CHARLESTON COUNTY COUNCIL PUBLIC HEARING Tuesday, December 6, 2022 at 6:30 PM

a. <u>ZREZ-07-22-00137:</u> Request to amend PD-152, Buckland Plantation Planned Development, to PD-152A, Buckland Plantation, to allow for different lot configurations, an additional waterfront lot, community docks and updates to meet wetlands, stormwater, and current Planned Development requirements.

PD-152A: BUCKLAND PLANTATION AMENDMENT REQUEST ZREZ-07-22-00137 CASE HISTORY

Charleston County Planned Development Amendment Request

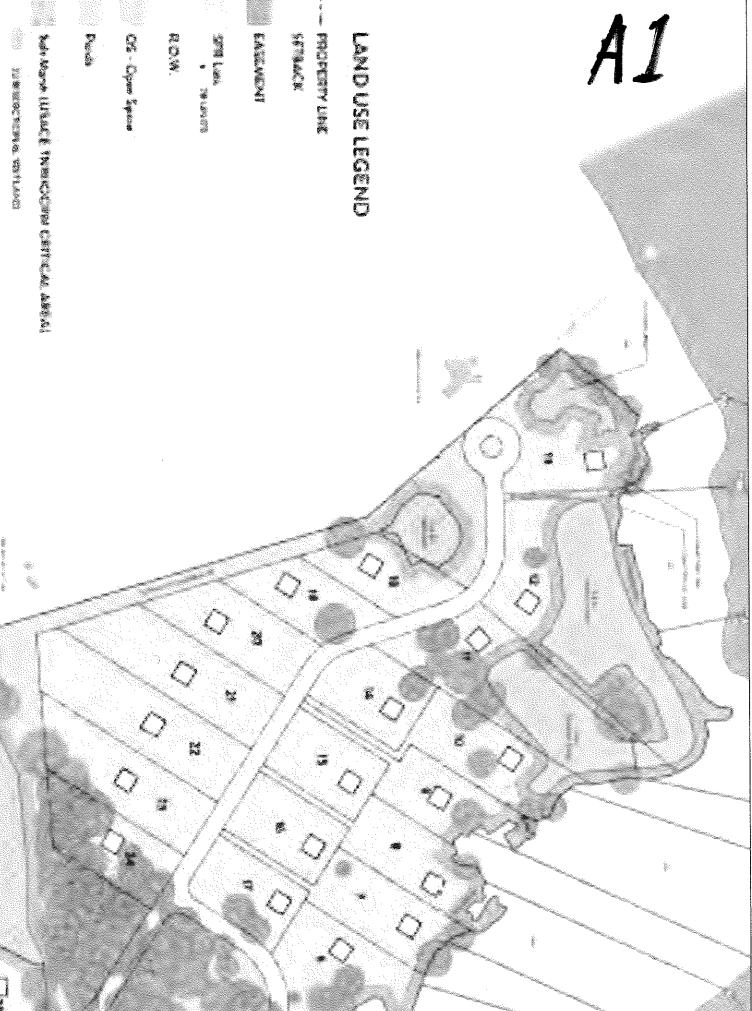
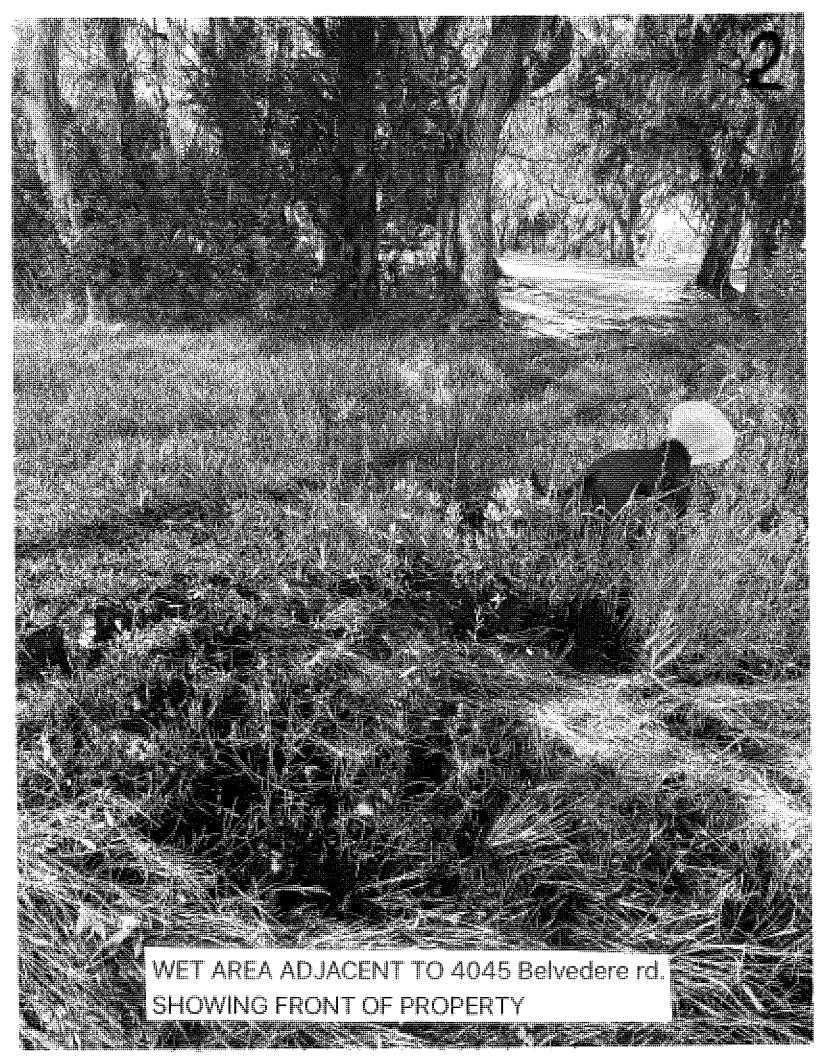
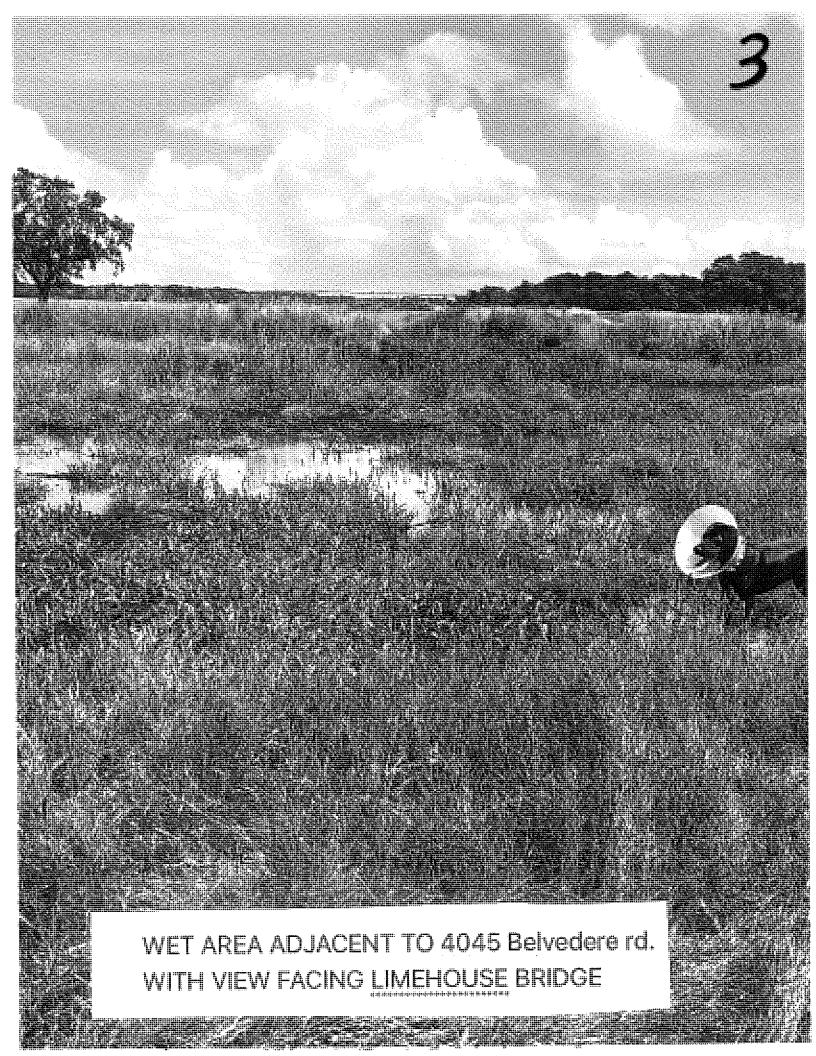
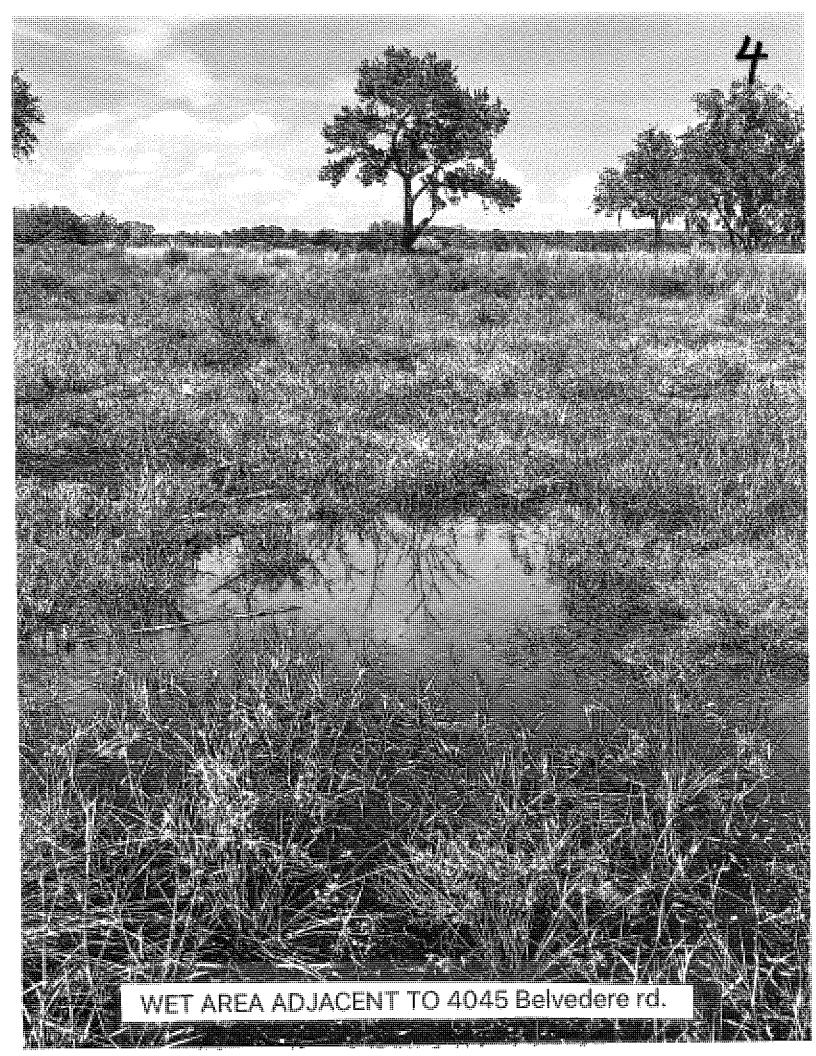
You can see in the photos 1-5 that wet lands are right against my property ...if you fill in that long strip of low land it WILL flood my property.

Photos 6-9 addresses alternative places to make your turn around instead adjacent to my home. One of the options are high areas of land on the North side of the property. Also the land between the pond and the Stono river is usable for parking.

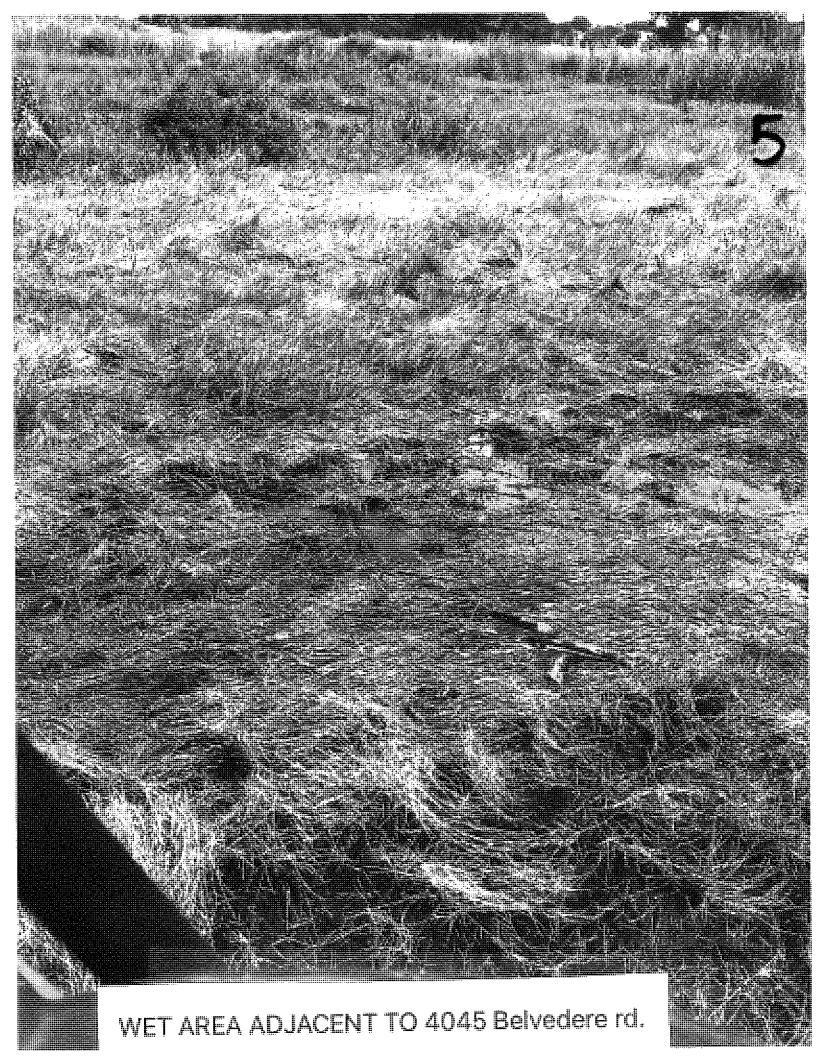
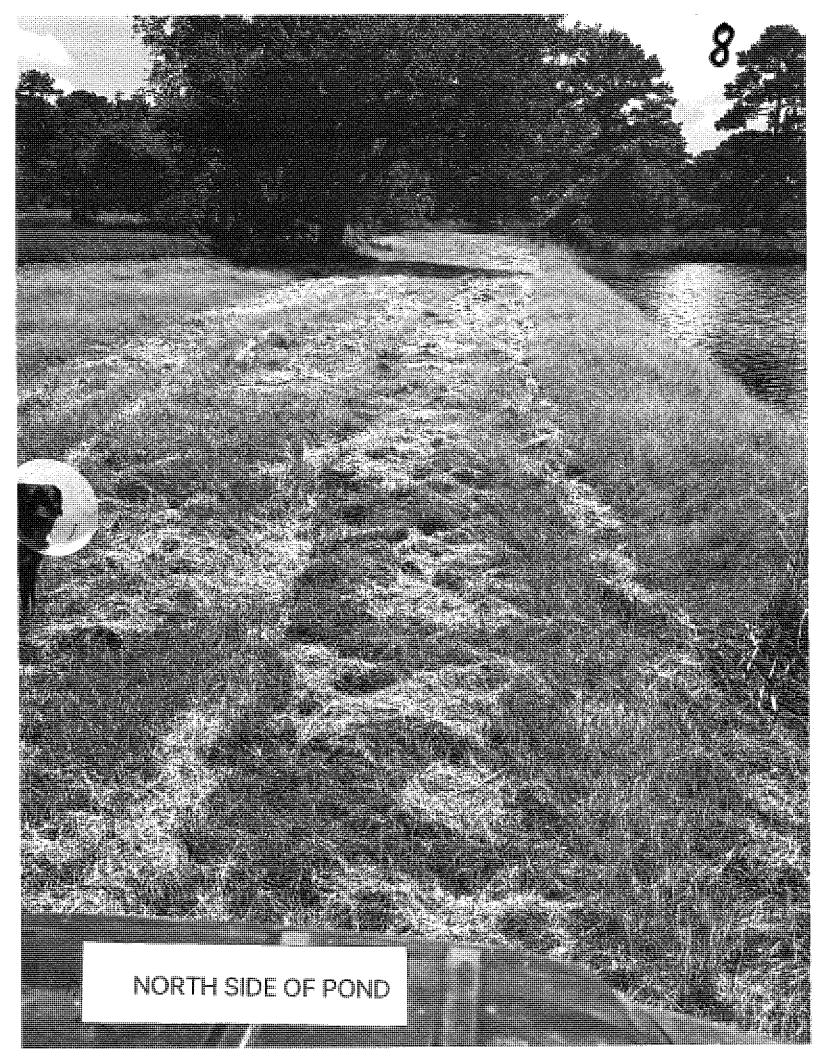
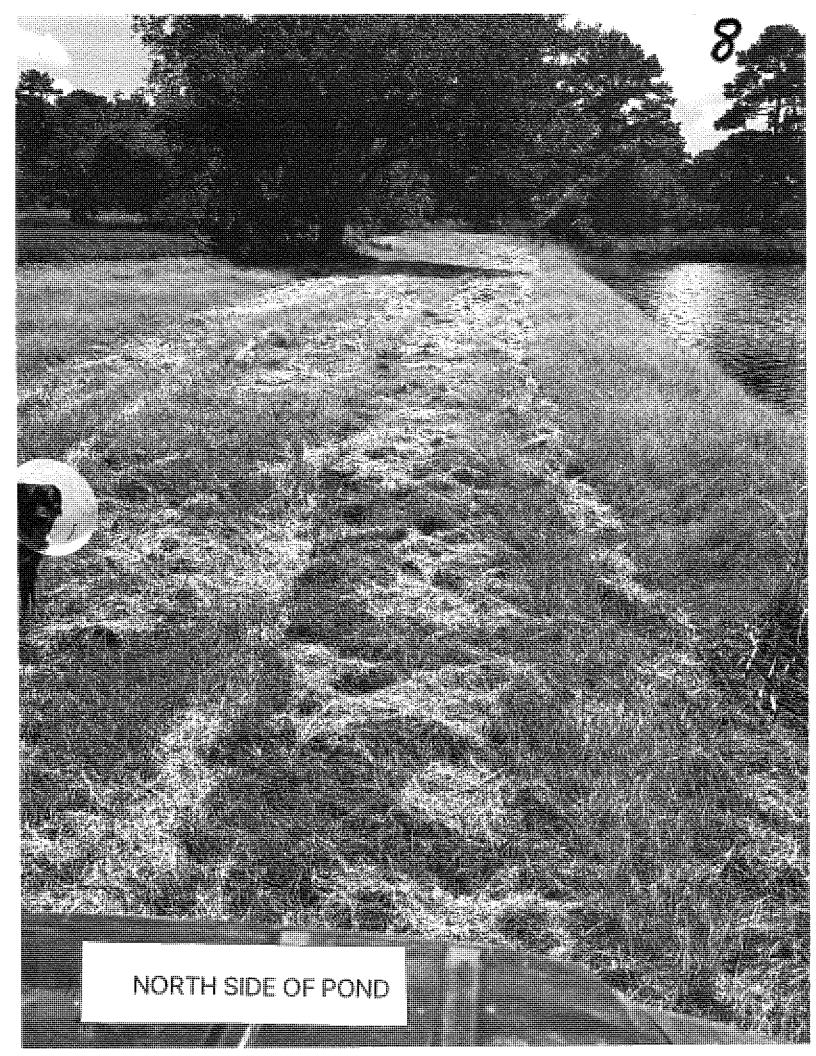
Photos 10-12 are of the Peninsula that is a spacious area for parking and gathering.
